## SITE INVESTIGATION AND REMEDIATION WORKPLAN

Facility Name: Wolf Creek Unit-Govt-69S90W1SWNE

**Wolf Creek Unit – Govt #5, Site Investigation Remediation Workplan**

**Form 27 Conditions of Approval (COAs)**

## National Wetlands Inventory

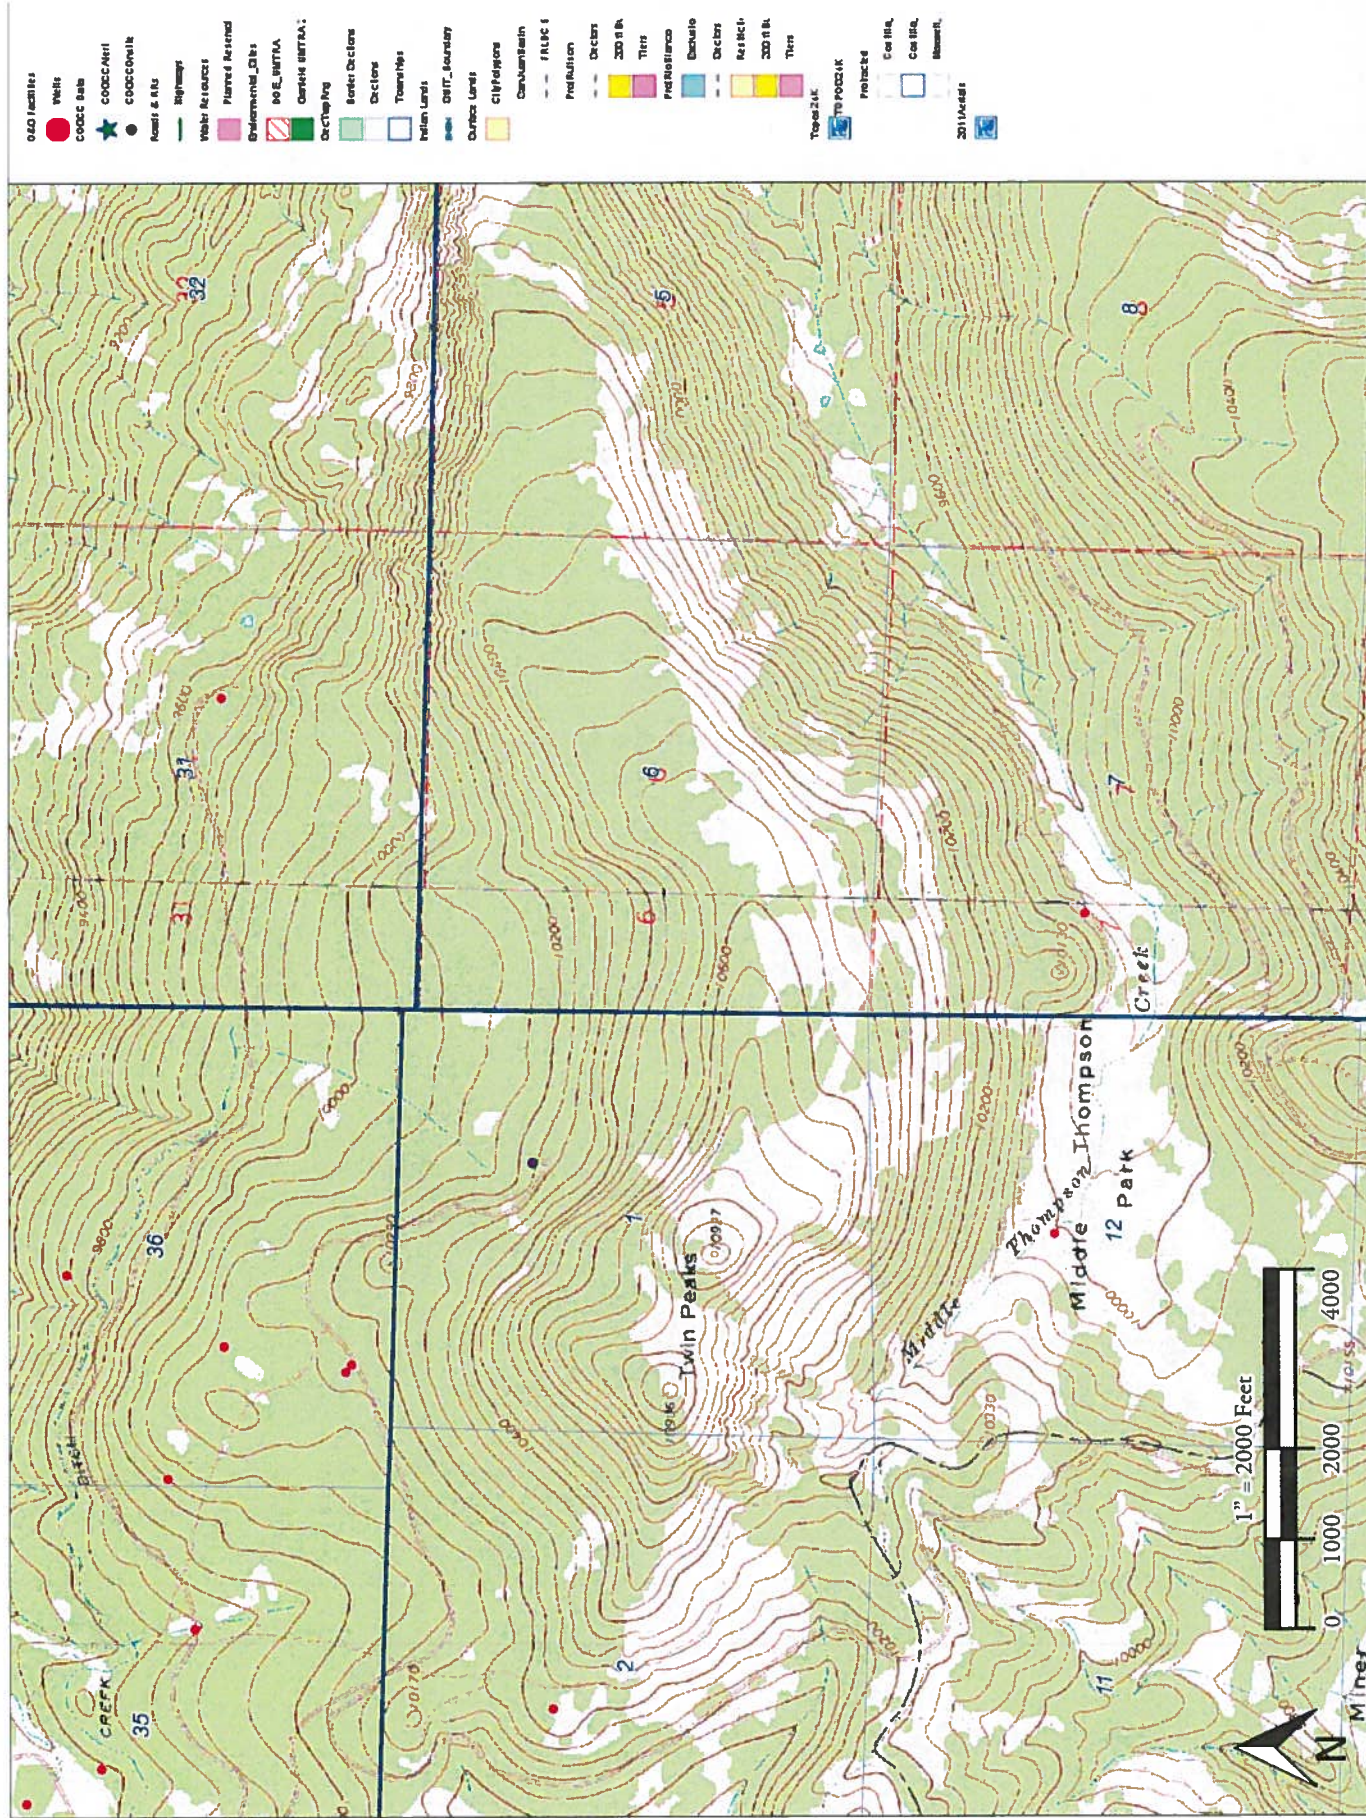
- Based on the shallow depth to groundwater, the COGCC conducted a desktop review of the site to identify the potential presence of jurisdictional wetlands within the vicinity of the release area. Upon review of the National Wetland Inventory (NWI) map of that area, as prepared by the US Fish and Wildlife Service (USFWS) (<http://www.fws.gov/wetlands/Data/Mapper.html>), a potential jurisdictional wetland may be located within or adjacent to the release. The wetland is depicted as a Palustrine Scrub-Shrub, Saturated (PSSB), as defined by the USFWS. A copy of the NWI map is attached for your review.

The COGCC suggests that the operator verify the presence and jurisdiction of the wetland. The Sacramento District of the US Army Corps of Engineers (USACE) contact information for the Grand Junction field office is provided below.

- Based on the review of the Sensitive Area Determination Checklist, a determination of “No” was applied to Question 2) could a potential release from the facility reach surface water features? Further review of the NWI map and the USGS topographic map determined the proximal down-gradient locations of two surface water features, one wetland and one ephemeral stream. Based on these locations, a potential release from the facility to surface water features is possible. A copy of the NWI map and USGS topographic map are attached for your review.
- Upon receipt and review of the requested information and subsequent forthcoming information from the installation of additional piezometers, the COGCC reserves the right to modify the seeps/springs, and piezometer/groundwater monitoring well schedule.
